Docket Item #9A&B
DEVELOPMENT SITE PLAN #2004-0038(A)
SUBDIVISION #2006-0006(B)
TAFT AVENUE

Planning Commission Meeting
February 6, 2007

REQUEST: Consideration of (1) a request for a development site plan, with modifications, to construct thirteen (13) single-family dwellings and (2) a request to resubdivide 5 lots.

Figure 11: Threshold Height by "Blocks"

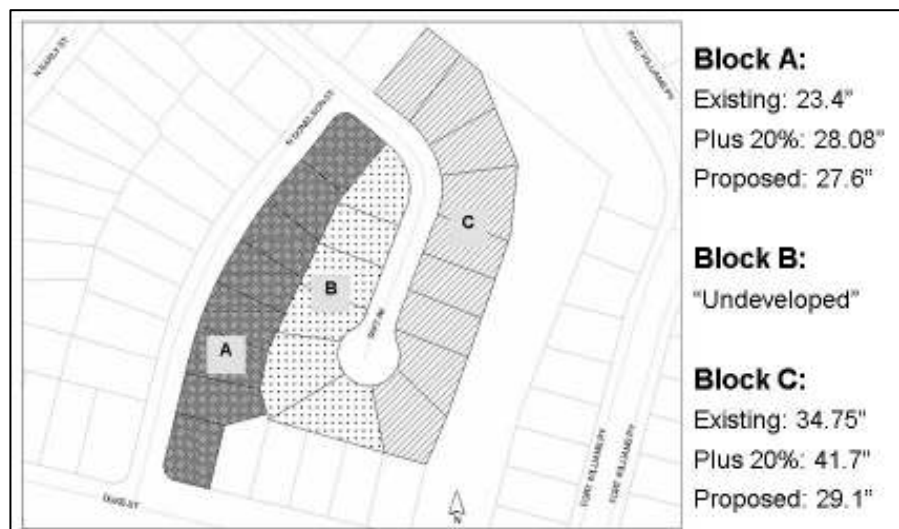
This provision was added to ensure that developers do not artificially raise natural grade to make the homes appear larger which in turn makes the grade and the home much different than the adjoining homes. In this case, given the size of the project, there were actually three “blocks.” On one of those “blocks” (shown as Block B on the graphic), the majority of

the buildings will be demolished resulting in a block without developed thresholds, so the rule would not apply. Applying the rule to the other two blocks results in a finding that no SUP is required. While these are large homes, the existing grading will generally remain as exists today with the homes being approximately 2 feet above the adjoining grade. As depicted in the graphic, none of the front door thresholds exceed 20% of the existing homes.

Figure 14: Requested Side Yard Modifications

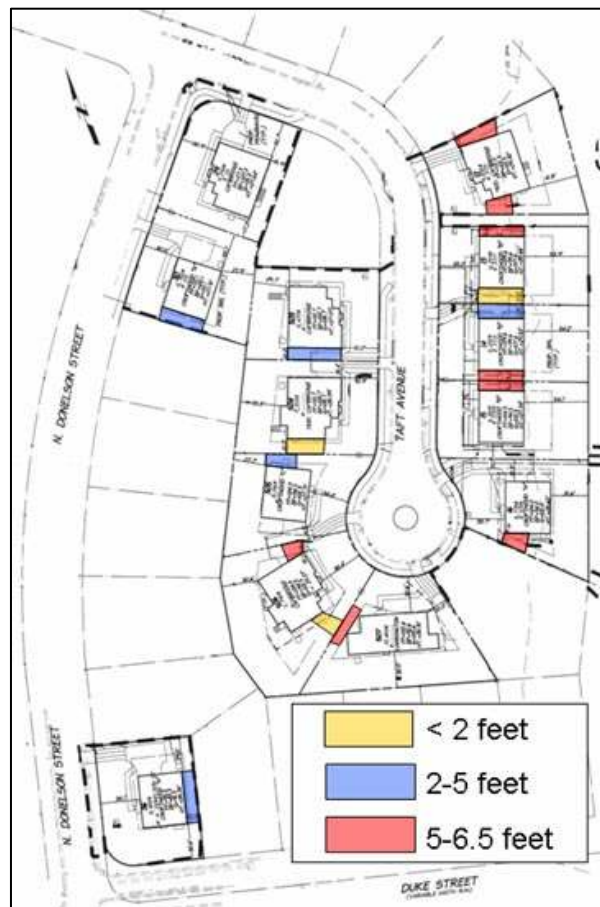
In two cases, the proposed modifications are necessary next to lots outside of the project. A right side yard modification of 5.4 feet is proposed for Lot 16, which is necessary to provide the side loaded garage and shared driveway. A left side yard modification of 6.5 feet is proposed for Lot 12, which is also

necessary given the narrowness of the frontage and the City's desire to move the building as far out of the RPA as possible. A condition has been added to require additional landscaping on these sides to help reduce the impact on the adjacent neighbors. The remaining side yard modifications affect only the other houses in the development, and since new owners will have a chance to accept or reject them, staff does not believe that they significantly harm the neighborhood.

There are two proposed modifications that staff feels are not necessary and should not be approved, particularly since these modifications affect lots outside of the development. A side yard modification of 4 feet is requested for the east side of Lot 36. However, the proposed home can be shifted 4 feet towards North Donelson Street to meet the setback. A right side yard modification of 3.6 feet is requested for Lot 30, but since the left side yard exceeds the setback requirement by 19 feet, staff is recommending that the house be shifted to meet both side yards.

In general, the side yard modifications are justifiable due to the positive contributions, such as shared driveways and side loaded garages, that will occur as a result. Staff is recommending approval of the requested side yard modifications, except for Lot 36 and Lot 30.

- a. The eastern side yard for Lot 36 shall be revised to comply with the required side yard setback (8 ft. min or ½ the building height, whichever is greater) by reducing the front yard setback from 34.1 feet to 30 feet.

- b. The southern side yard for Lot 30 shall be revised to comply with the required side yard setback (8 ft. min or ½ the building height, whichever is greater) by reducing the left side yard.

Figure 15: Subdivision Plan

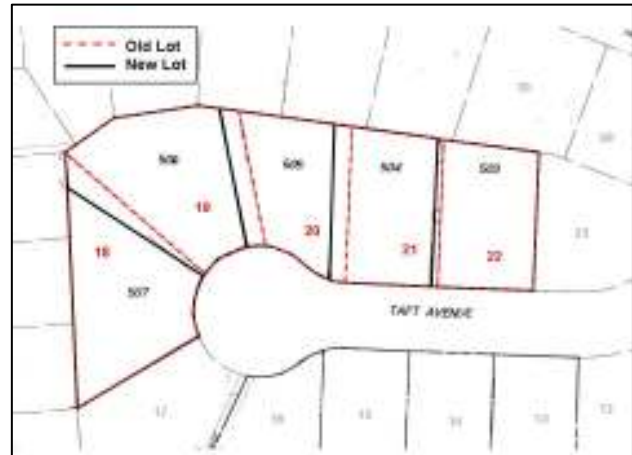
“No lot shall be resubdivided in such a manner as to detract from the value of adjacent property. Lots covered by a resubdivision shall be of substantially the same character as to suitability for residential use and structures, lot areas, orientation, street frontage, alignment to streets and restrictions as other land within the subdivision, particularly with respect to similarly situated lots within the adjoining portions of the original subdivision. In determining whether a proposed lot is of substantially the same character for purposes of complying with this provision, the Commission shall consider the established neighborhood created by the original subdivision, evidence of which may be shown by (1) subdivision plat documents, including amendments to the subdivision over time, as well as the development that has occurred within the subdivision; and (2) land in the same general location as the original subdivision with the same features so as to be essentially similar to the original subdivision area”.

Under the amended subdivision language, the proposed new lots are required to be compared to those in the original and essentially similar subdivision area, to assess whether the character of the new lots is compatible with the character of the existing surrounding lots. In this case, the resubdivision creates only minor changes (5 to 25 foot shift in the lot lines), resulting in similarity in size, shape and orientation of the new lots when compared to the existing lots and when compared to lots in the immediate neighborhood.

Figure 16: Proposed RPA Encroachment

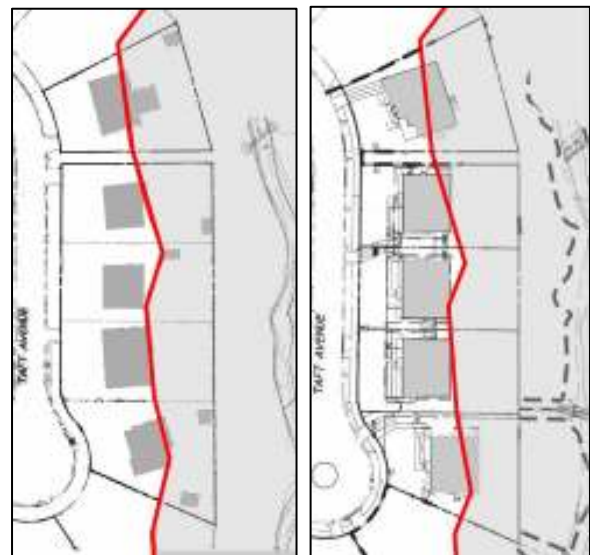
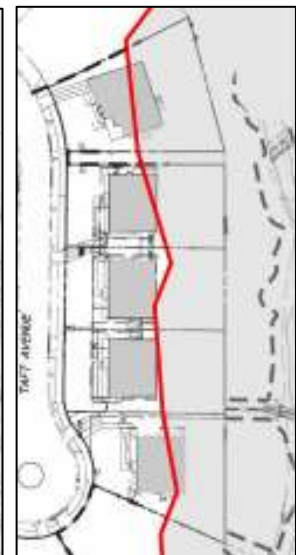
Because a 30 foot front yard setback is a deed restriction in this neighborhood, if a full prohibition on future encroachment into to the RPA were required, those five lots would be essentially unbuildable. Therefore, the applicant has requested that some encroachment be permitted as shown in the proposed site plan.

The applicant has requested an administrative approval for encroachment into the RPA under Section 13-107(E)(1), Article XIII, Environmental Management, which regulates development within the Resource Protection Area (RPA). This section of the Zoning Ordinance specifies:

In this case, the proposal generally complies with the R-8 zone and is consistent with the City's Master Plan. As required by the Zoning Ordinance, the applicant has provided a water quality impact assessment for review by T&ES. Calculations of the proposed development show that 1,454 sq.ft. of impervious area will be constructed within the RPA, with a reduction in impervious area on each lot. The encroachment into the RPA will be at the edge of the RPA boundary and the sheds currently existing in the rear of the lots that are close to the stream will be removed, thus eliminating the most near-stream encroachments into the RPA. Finally, the proposal complies with stormwater management requirements, largely due to the provision of a stream restoration plan.
